Planning Approval Consistency Assessment Form

| Assessment Name: | Second Avenue |
| Assessment number: | AFJV02 |
| Planning approval: | CSSI 10038 Sydney Metro West Concept and Stage 1 |

Figure 1 Five Dock Station indicative construction site layout (source: EIS Figure 9-28)

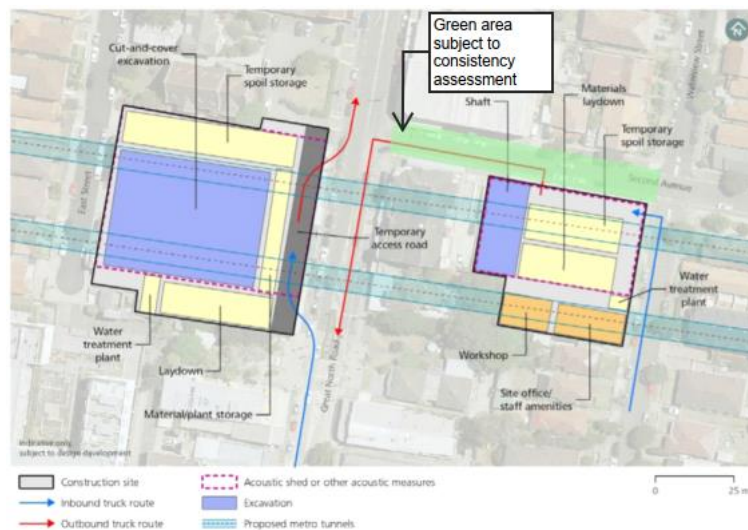
A description of the Five Dock construction site is presented in Section 9.5.8 of the EIS. The site is made up of two individual sites, the Five Dock western construction site and the Five Dock eastern construction site. This consistency assessment is in relation to the Five Dock eastern construction site. Figure 9-28 of the EIS identified that heavy vehicles will enter the Five Dock eastern construction site from Waterview Street in a northerly direction and exit on Second Avenue in a westerly direction. This is shown in Figure 1.

The proposed layout for the temporary change is shown in **Appendix A**. Heavy vehicle inbound and outbound routes remain consistent with the EIS as shown in Figure 1.

Appendix A Proposed layout, traffic guidance and swept path analysis

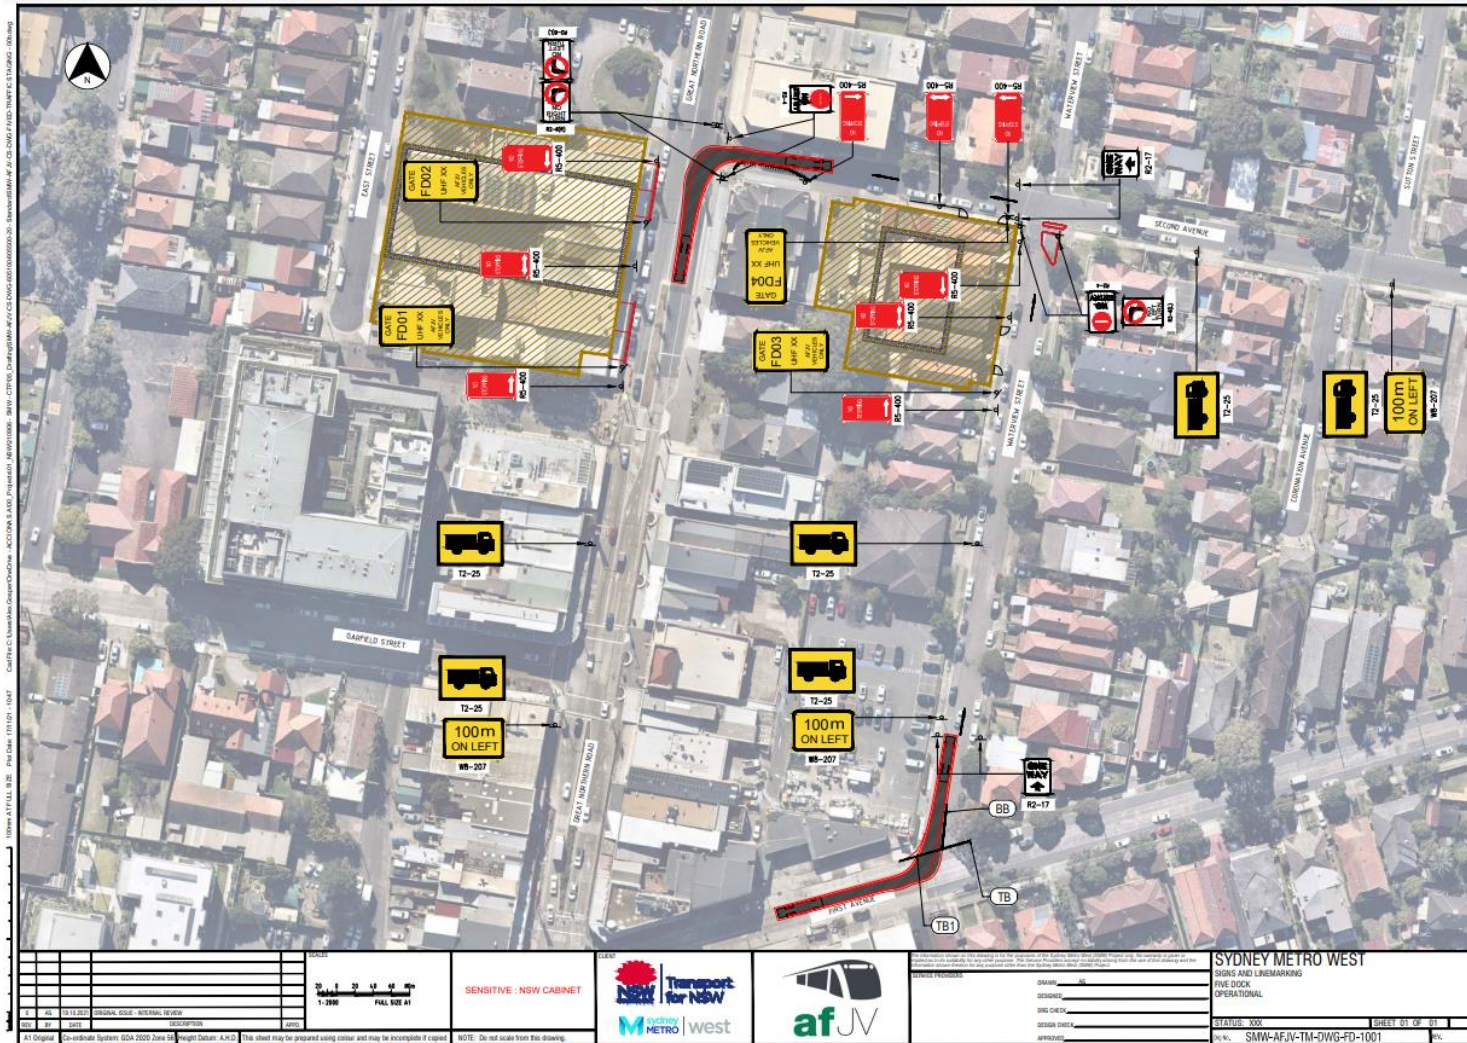
The proposed change being assessed involves the conversion of Second Avenue between Great North Road and Waterview Street, Five Dock, from a two-way road to a one-way road (westbound only) during construction. This would involve the installation of signage, bollards and new line markings to indicate the one-way access.

Appendix A includes a figure of the proposed layout of Second Avenue and surrounding areas.

A swept path analysis has been conducted by AFJV for the site. The swept path analysis identified that under the current arrangement on Second Avenue (i.e. as a two-way street) heavy vehicles exiting the eastern site would be required to cross the centre line to safely exit the site, potentially coming into conflict with traffic in the opposite direction. In addition, the existing intersection on Second Avenue onto Great North Road is particularly narrow, again potentially putting heavy vehicles into conflict with oncoming traffic and making it impractical and unsafe to retain a two-way intersection onto Second Avenue.

The proposed one-way arrangement retains a more safe left-turn for heavy vehicle movements onto Great North Road, while reducing the extensive civil works that would be required to widen this intersection and create a safe movement. This civil work would include reducing the existing pavement width, widening the existing road of Second Avenue near Great North Road, and extensive utilities relocations which could
